4K Camera PCB ver.
12/17/20

FEEDBACK ON LAYOUT

TOP COPPER

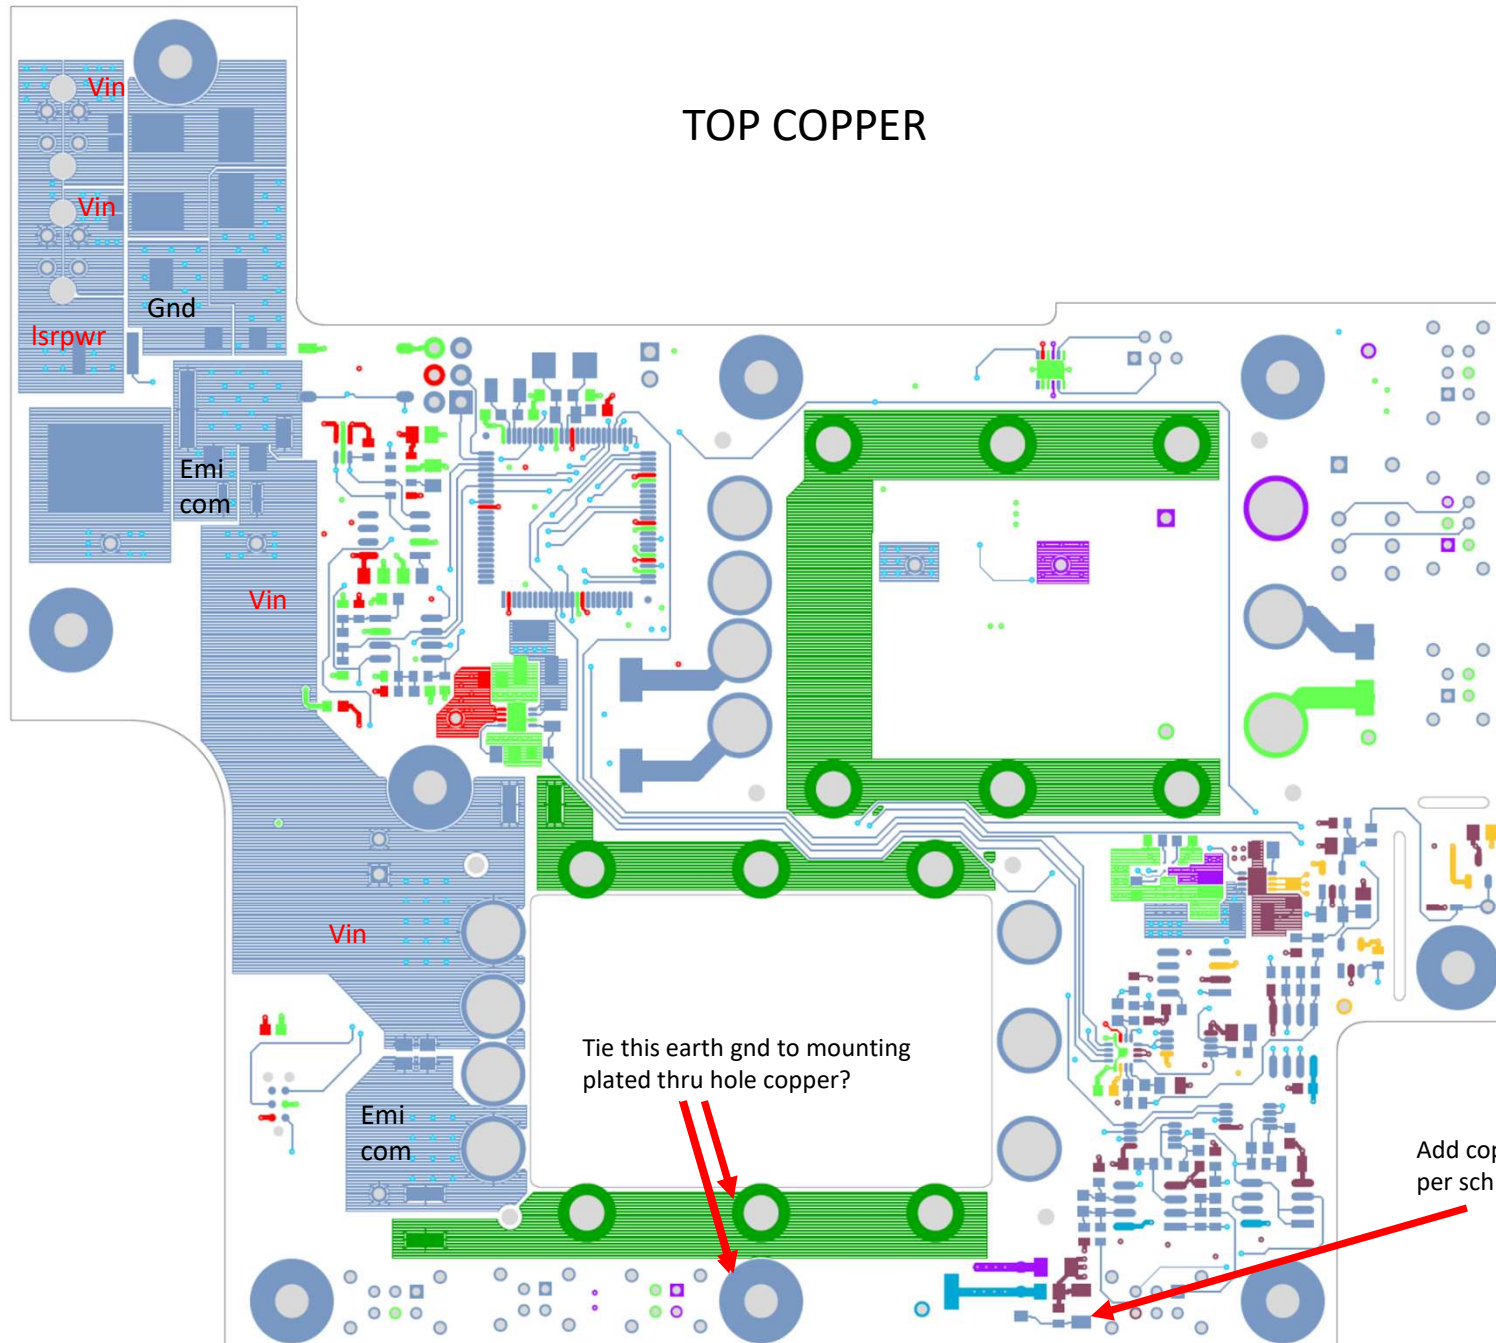
Move components outside thermal cutout area and move U28 as close as possible to mounting hole?

IN4 COPPER

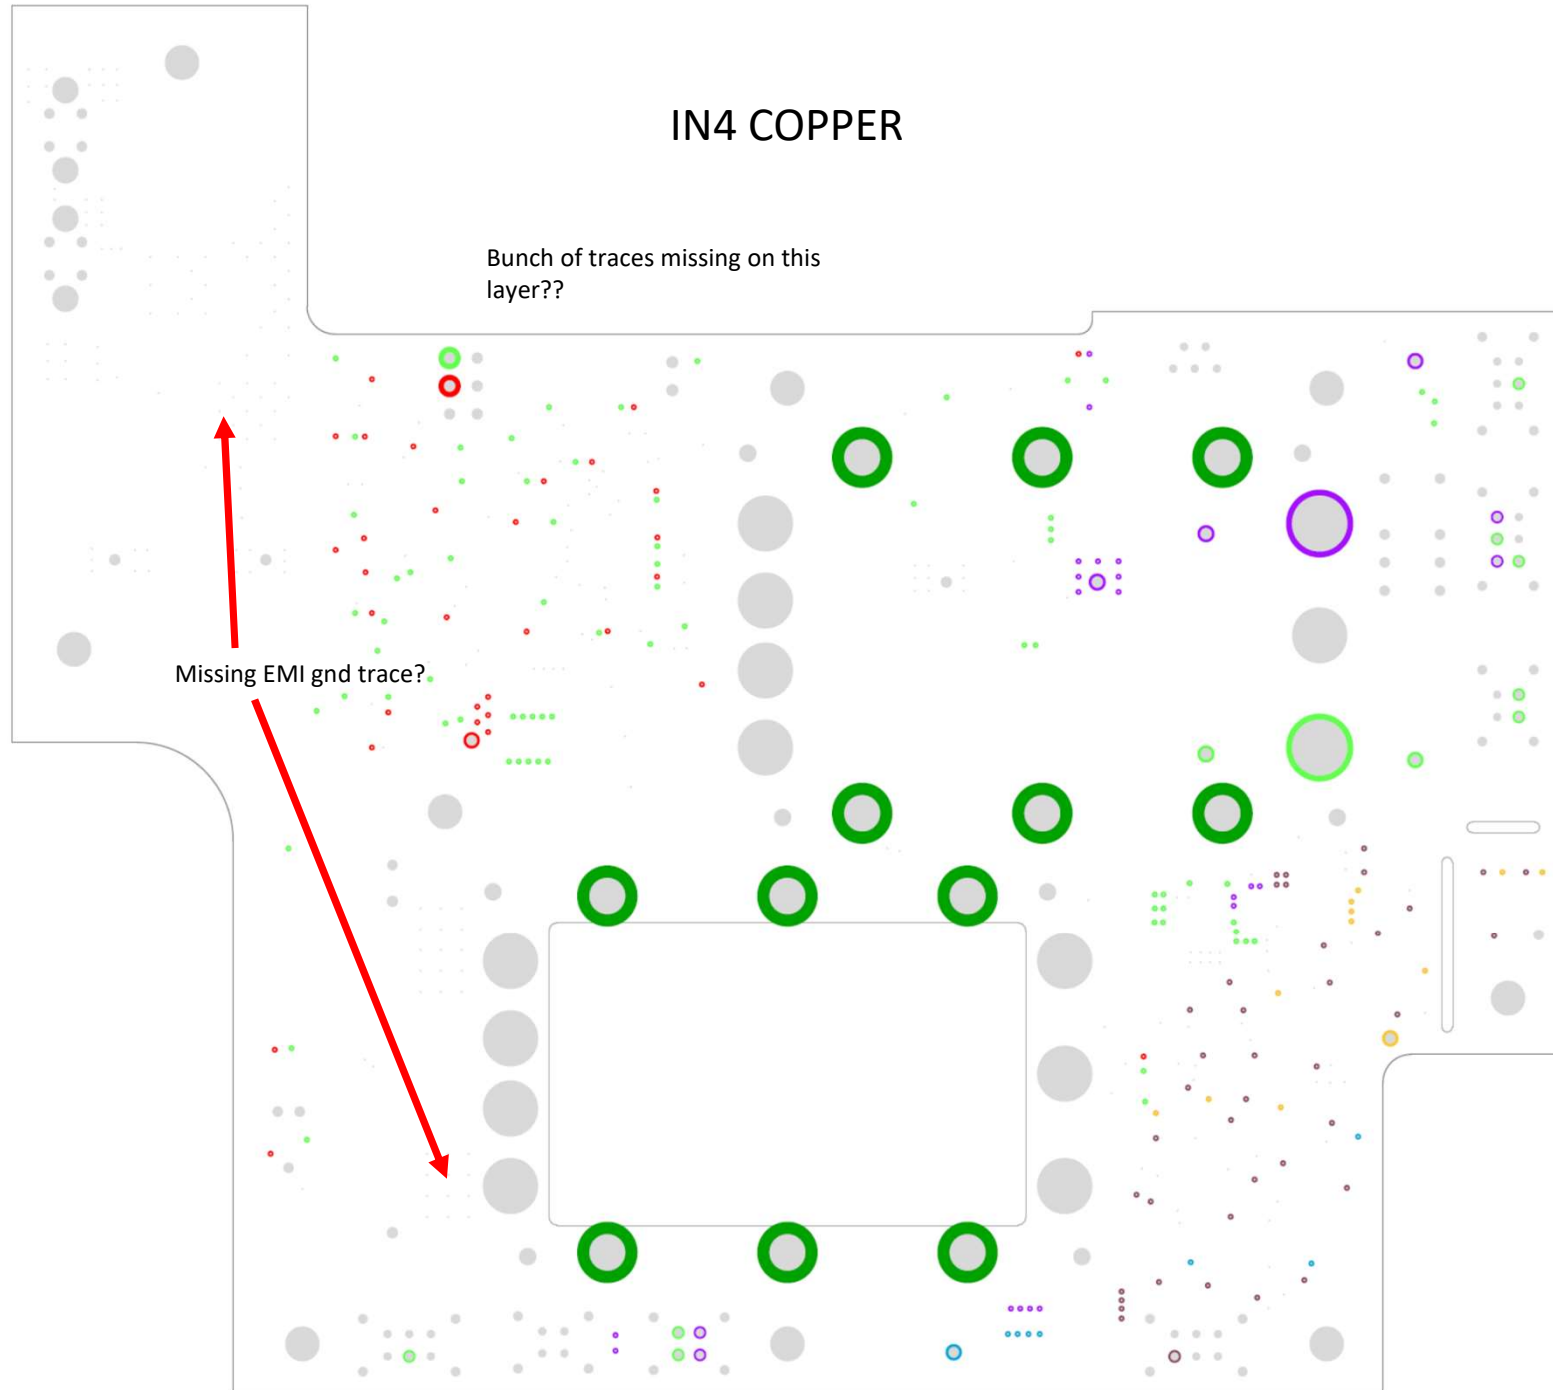
Tie this earth gnd to mounting plated thru hole copper?

Add copper and guard ring as per sch note 2 & 3.

Bunch of traces missing on this layer??

Missing EMI gnd trace?

IN2 COPPER

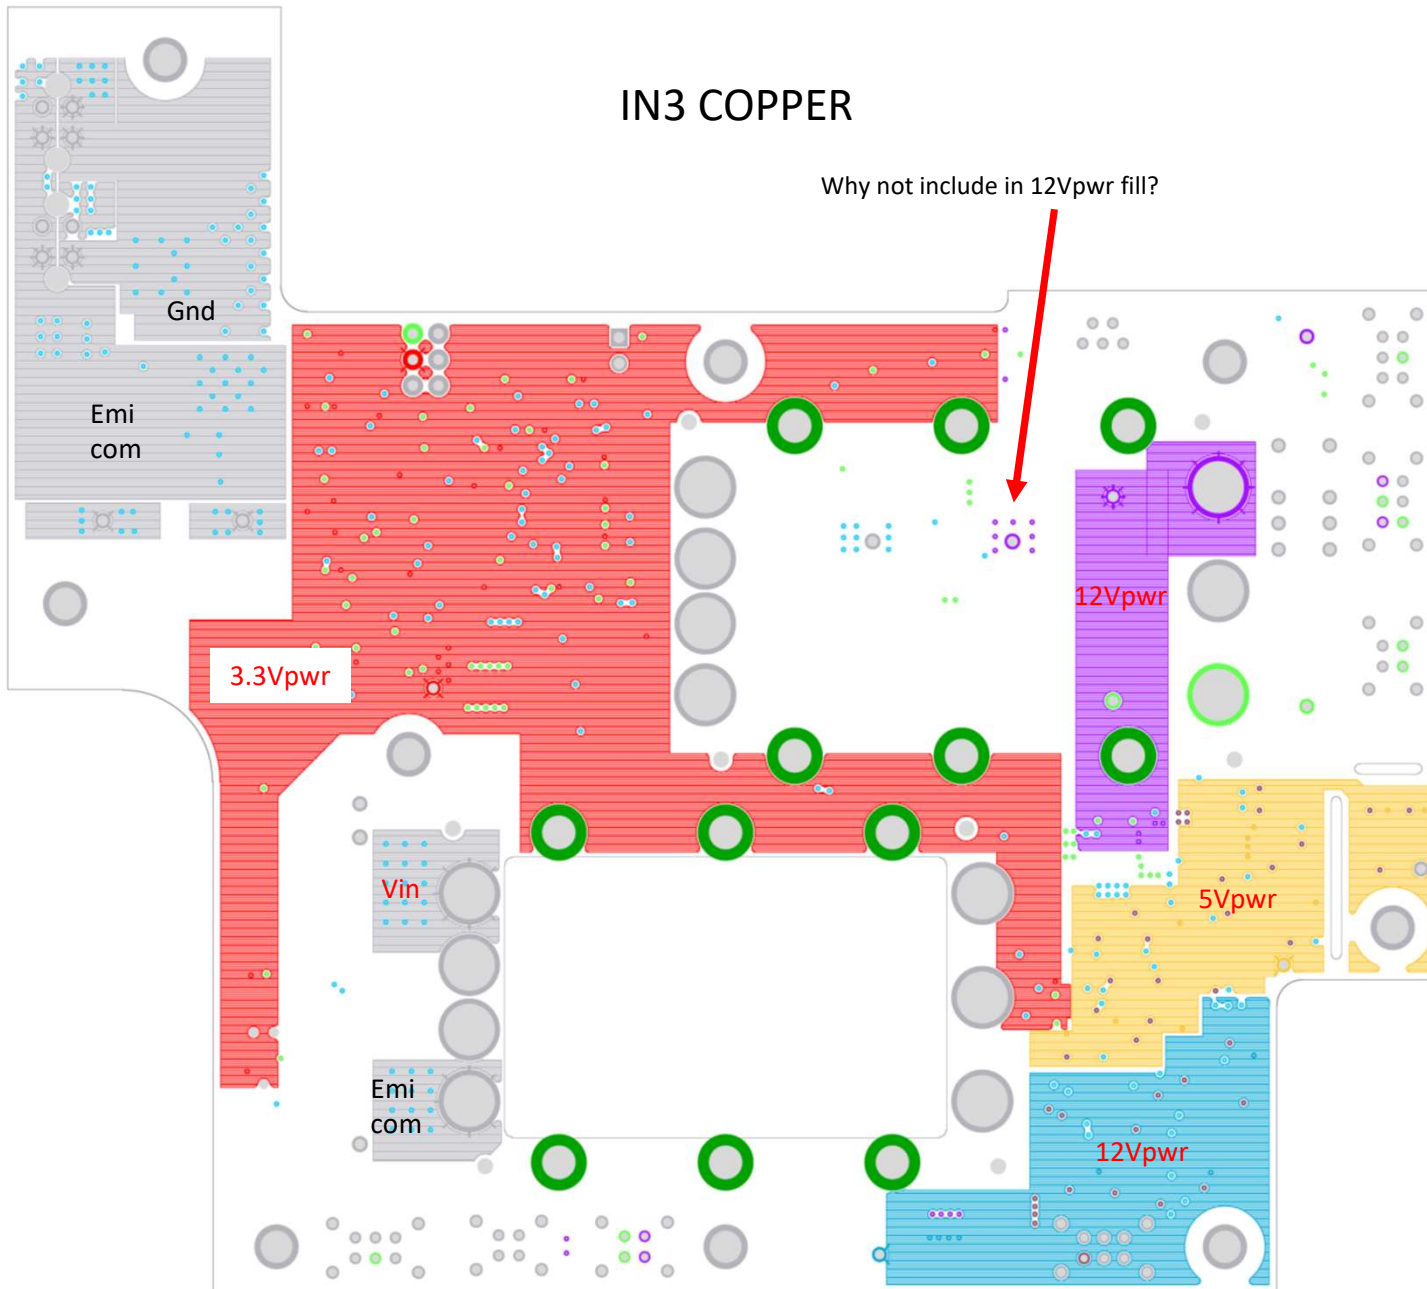
Why not include in 12Vpwr fill?

IN1 COPPER

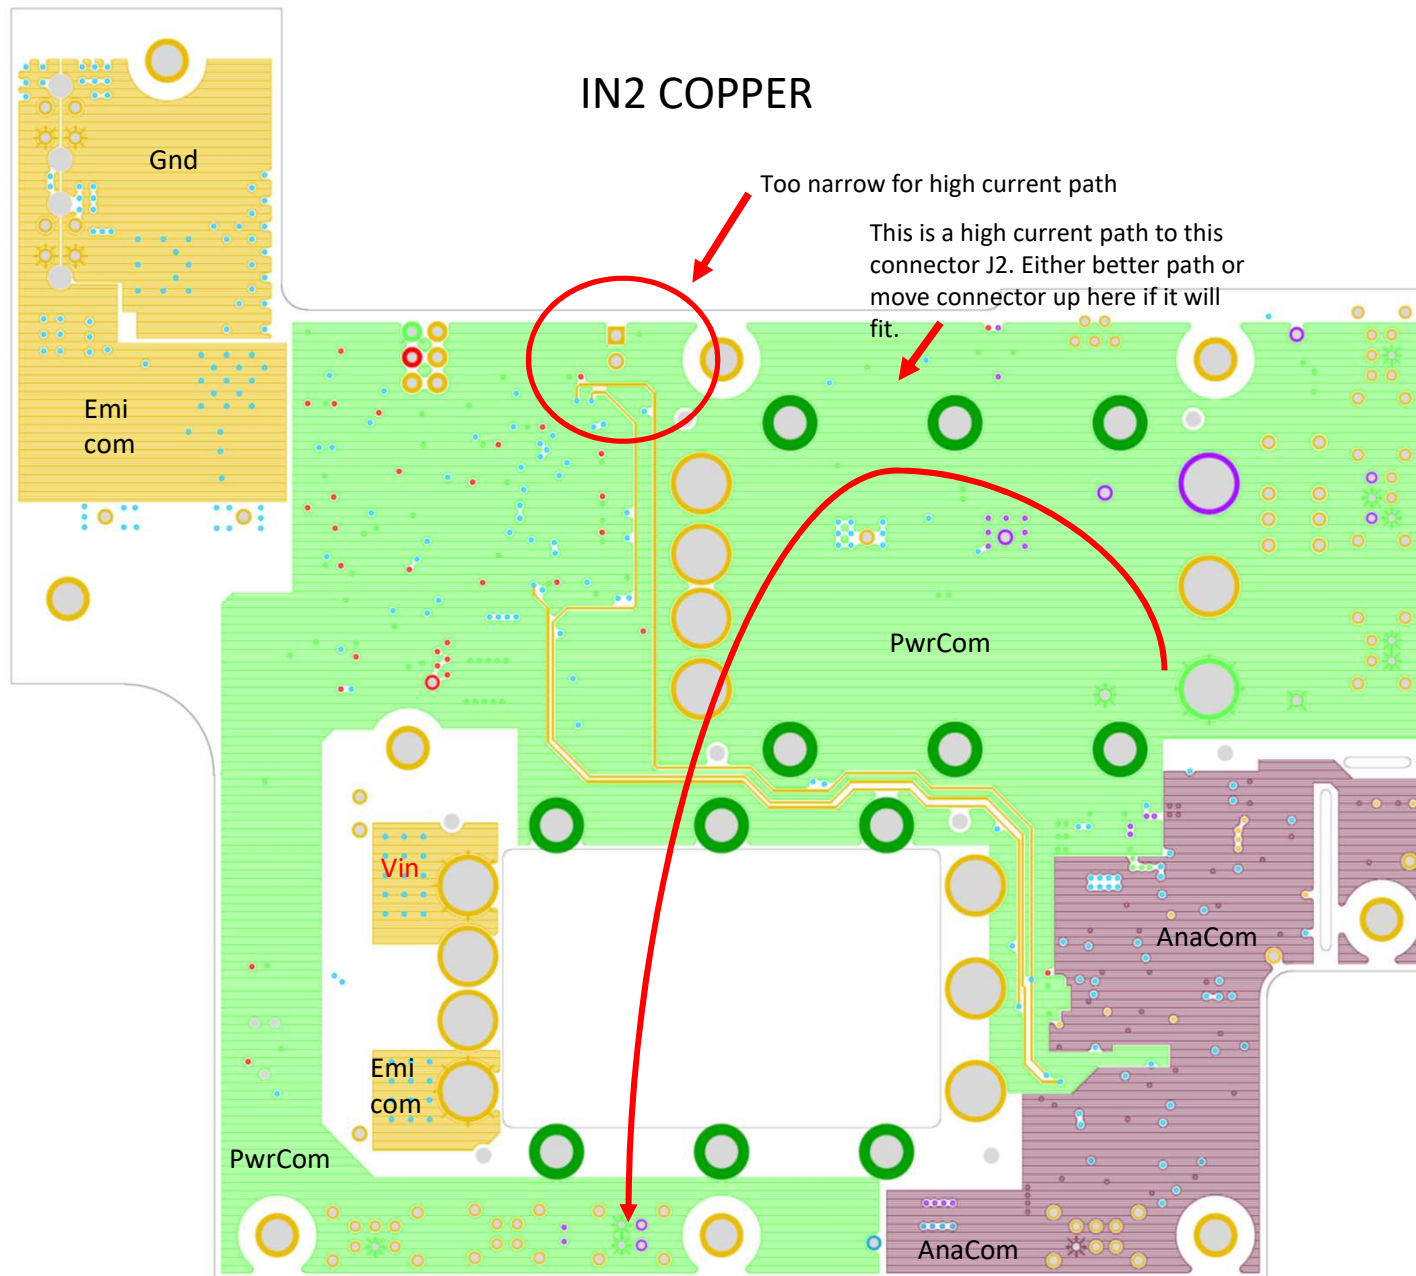
Too narrow for high current path

This is a high current path to this connector J2. Either better path or move connector up here if it will fit.

More fill?

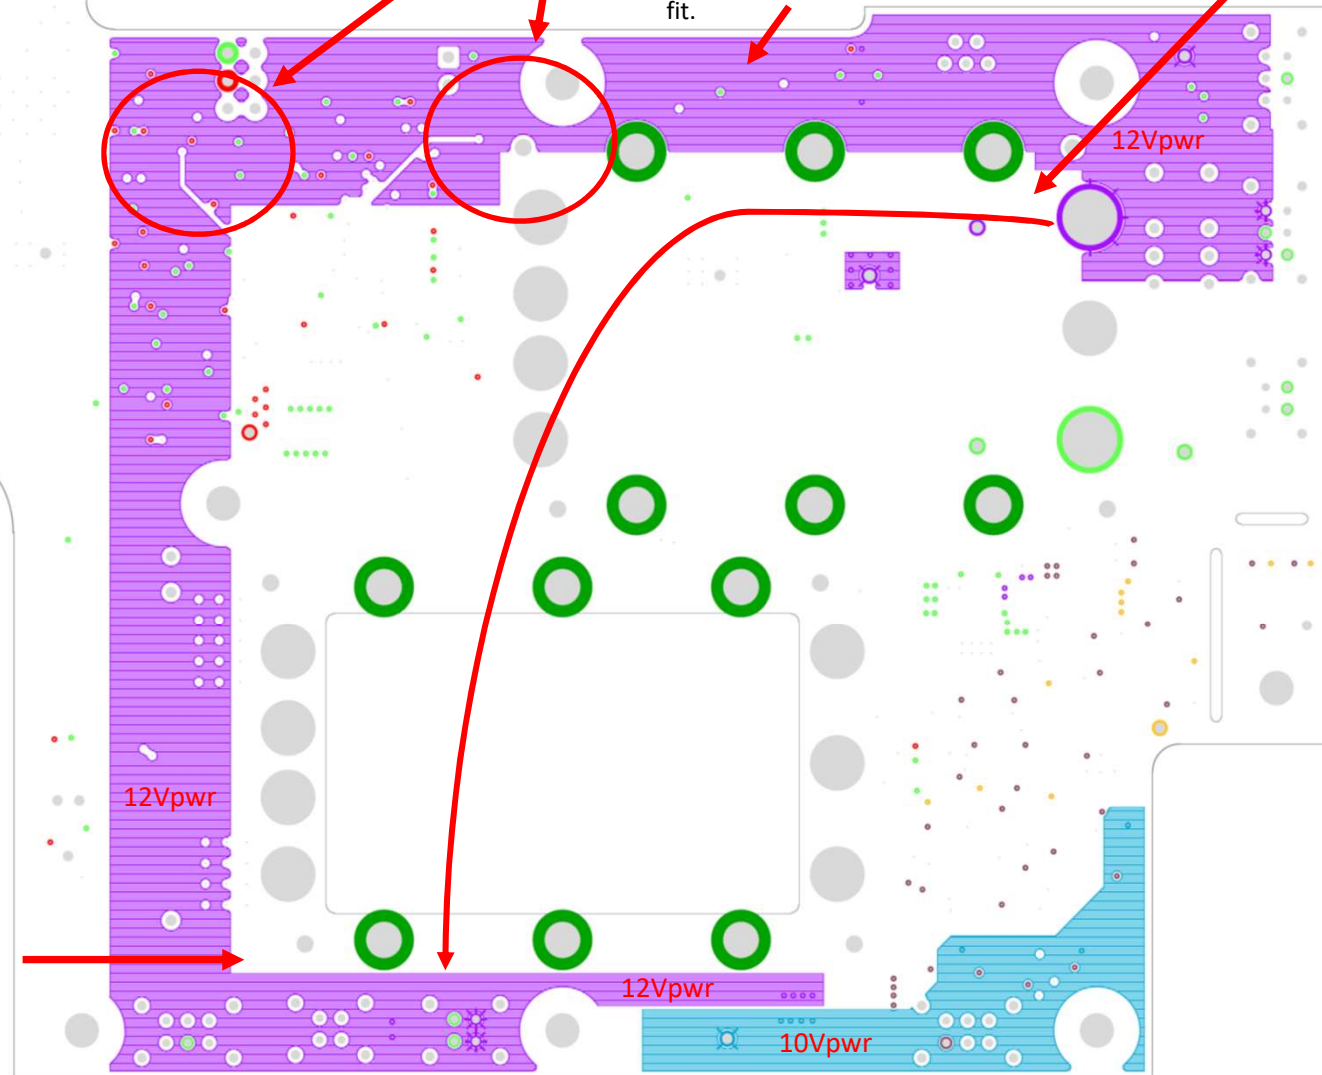
More fill?
